<b>Technical Service Bulletin:</b> TSB180058	<b>Released Date:</b> 27-Feb-2019
<b>Belt Noise and Front Engine Accessory Drive Belt Re-routing: Tiffin Recreational Vehicles</b>

## Belt Noise and Front Engine Accessory Drive Belt Re-routing: Tiffin Recreational Vehicles

Figure 3, Original Design (Tiffin RV). Compressor Belt Has Already Been Removed From This Figure.

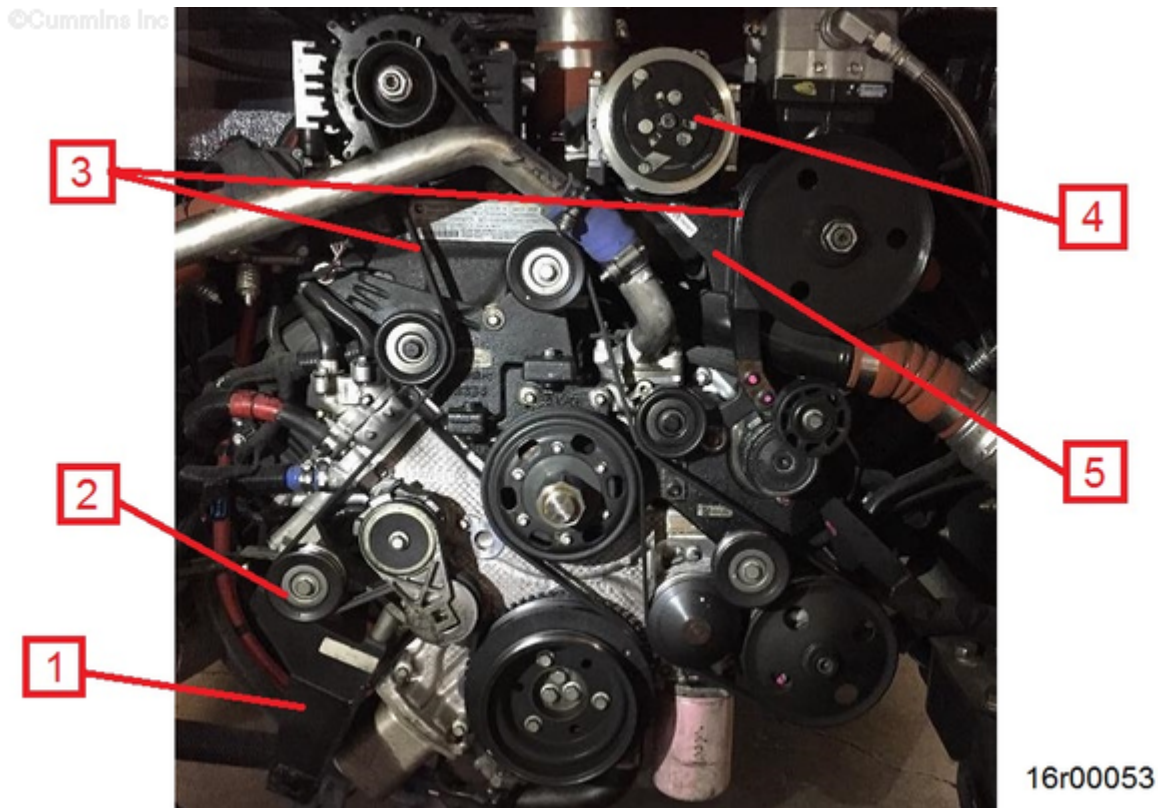
1. Refrigerant compressor wiring connector.
  2. Refrigerant compressor supply and return lines.
4. Remove and discard belts, Part Number: 4335361 and 4335602 (Figure 3).
  5. Remove and discard lower idler pulley assembly, Part Number 4390735 (Figure 3).
  6. Remove refrigerant compressor (Figure 3) from upper refrigerant compressor support.
    - a. Mounted on refrigerant compressor support bracket, Part Number 4360003 (Figure 3).
    - b. Two Sanden refrigerant compressor models have been identified as being used in Tiffin production.
      - i. Model number U4520 - replace with model number U4883
      - ii. Model number U4897 - replace with model number U4883

1. OEM Lower Fan Shroud Support Bracket.
  2. Lower Idler Pulley.
  3. Belts to be removed.
  4. Refrigerant compressor.
  5. Upper refrigerant compressor Support.
7. Remove L-Bracket (Figure 4 - 7) and P-clamp (Figure 4 - 8) assembly from lower accessory support, Part Number 4390708 (Figure 4 - 9).
- Disconnecting P-clamp from bracket is **not** necessary.
8. Remove OEM lower fan shroud support bracket (Figure 4 – 4) mounted to lower accessory support bracket, Part Number 4390708, (Figure 4 - 9) and OEM fan shroud.
- a. Reuse p-clip mounting bracket (Figure 4 - 7), capscrews, washers, and nut at fan shroud position. (Figure 4) Tighten all fasteners to proper specifications.

- Move refrigerant compressor from high mount to low mount. See Service Instructions section below.
- Install new Tiffin fan shroud mounting brackets.

- Change belt options to CP80008 and WP80038 for increased belt wrap on second belt plane around the air compressor.

Figure 4, Lower Accessory Drive Mounting with L-Bracket and P-Clamp.

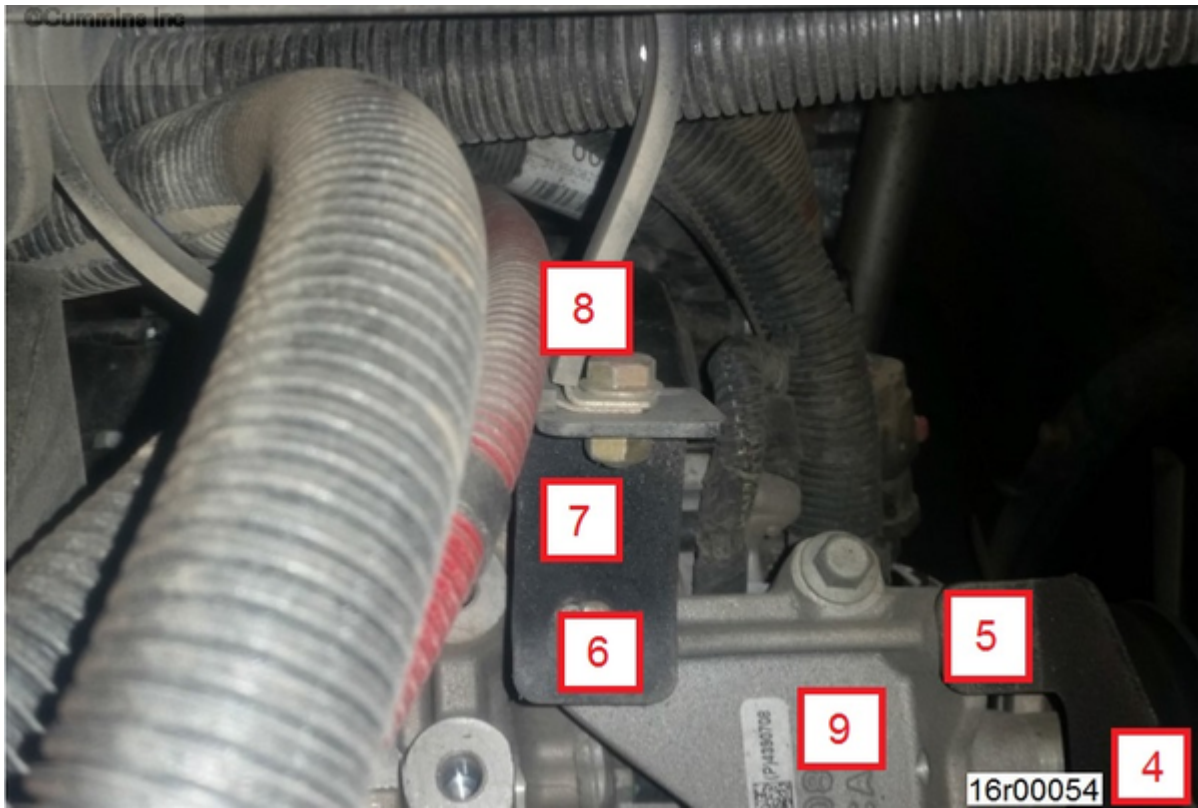
9. Install Sanden refrigerant compressor on lower accessory support, Part Number 4390708 (Figure 4 - 9).

- Do **not** tighten capscrews at this time.
- Reuse two of the OEM supplied refrigerant compressor mounting bolts from upper mount configuration. (capscrews M8 x 80mm x 1.25)
- Install first capscrew in the lower mounting hole towards the rear of the engine.
- Install second capscrew (Figure 4 - 6) through the L-bracket and P-clamp assembly (Figure 4 - 8) in upper mounting hole towards the rear of the engine.

**Note :** Note: P-clamp may be on the inner side of frame rail in original configuration, but P-clamp will move to the outer side of frame rail when repositioned.

Figure 7, OEM as built wiring harness routing to refrigerant compressor.

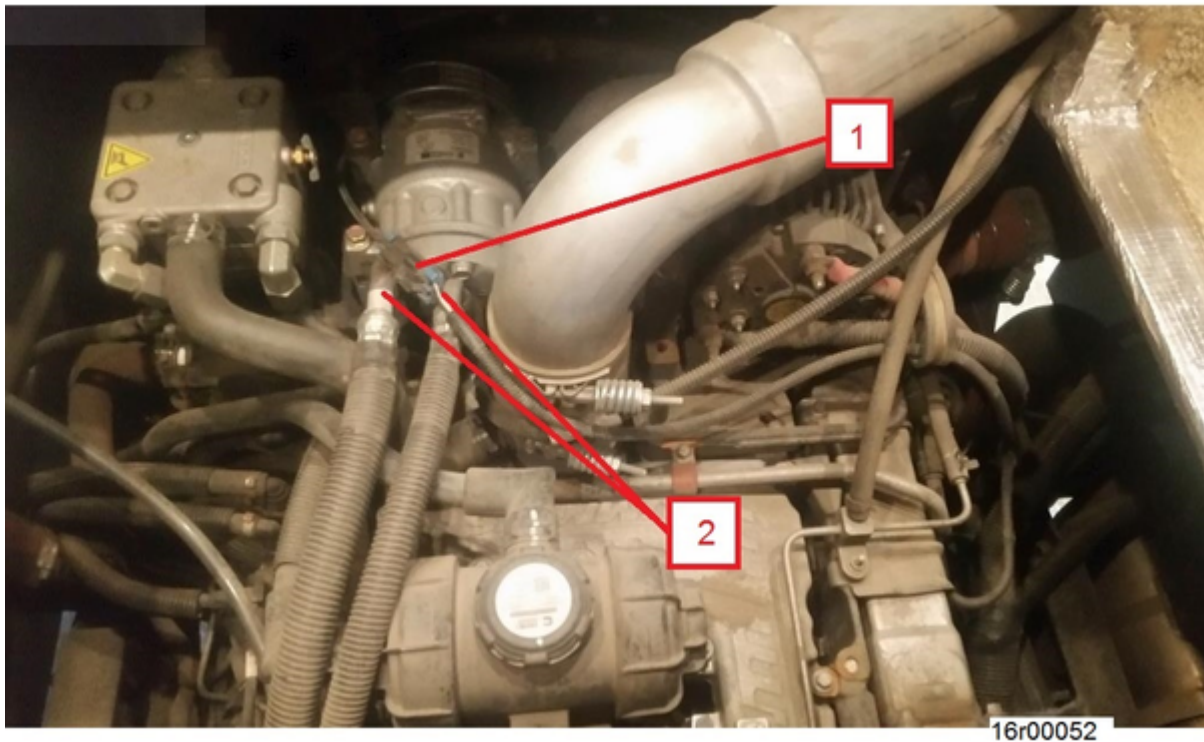
13. Wiring harness is long enough to route to new position.
  - a. Disconnect wiring connector at refrigerant compressor. Figure 7
  - b. Remove wire from p-clamp secured to alternator. Figure 8
  - c. Route wiring harness down to new refrigerant compressor location and connect to refrigerant compressor clutch connector.
  - d. Secure wiring harness with plastic ties away from heat sources. Bundle any extra length of harness.

Figure 10, New refrigerant Hose Routing.

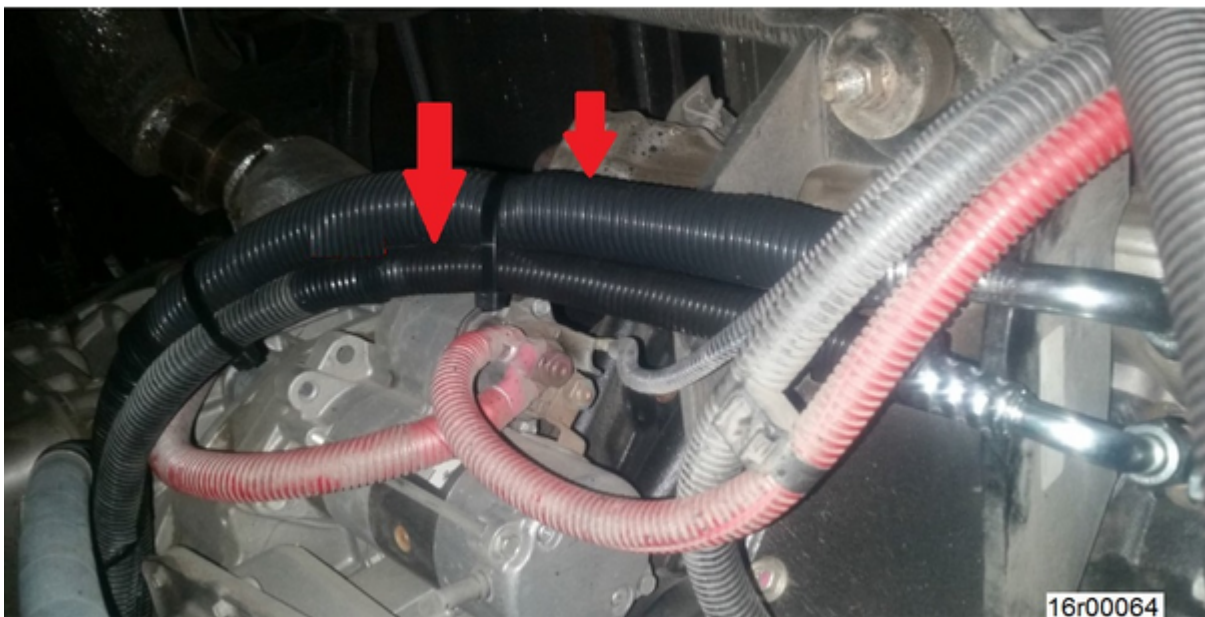
14. With refrigerant fittings disconnected from the upper position refrigerant compressor, cut plastic wire ties and remove p-clamps from original routing.
15. Pull hoses from clips and wire bundles.
16. With refrigerant hoses removed from original bundles, secure original bundles in p-clamps and replace plastic wire ties as needed.
17. Route hoses to new refrigerant compressor mount location. See Figures 8-11. Use OEM Hose kit (5076278) to attach existing hoses to new refrigerant compressor.
  - a. Secure with wire ties and p-clamps as necessary.
  - b. Secure away from heat sources.
18. Remove temporary caps and plugs.
19. Connect hose fittings to refrigerant compressor. Tighten to specifications. See equipment manufacturer service information.

Figure 12, New Belt Routing.

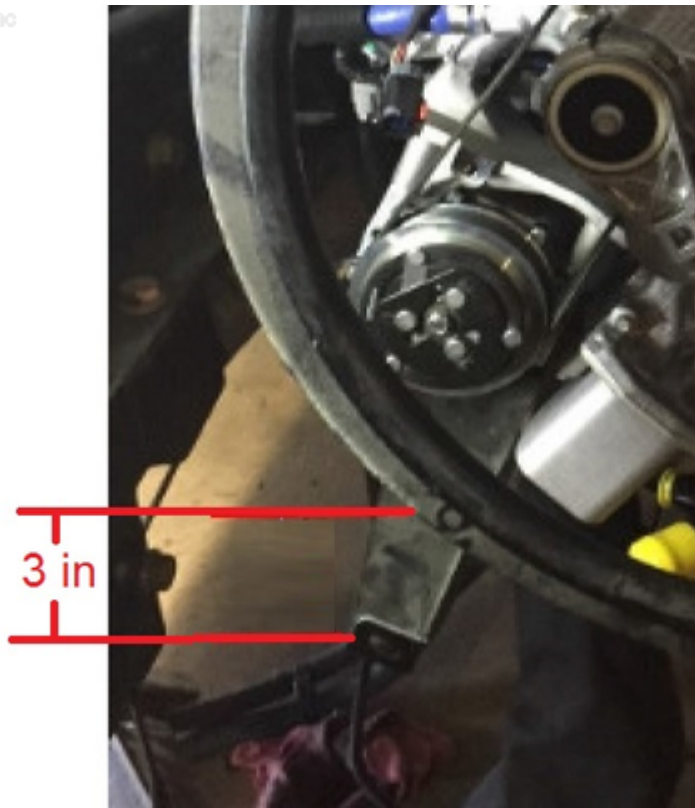
11. Install primary drive belt, Part Number 4335605, for fan, hydraulic pump, water pump, alternator, and lower refrigerant compressor (Option WP80038).
12. Install secondary drive belt for air compressor, Part Number 4391015. (Option CP80008)
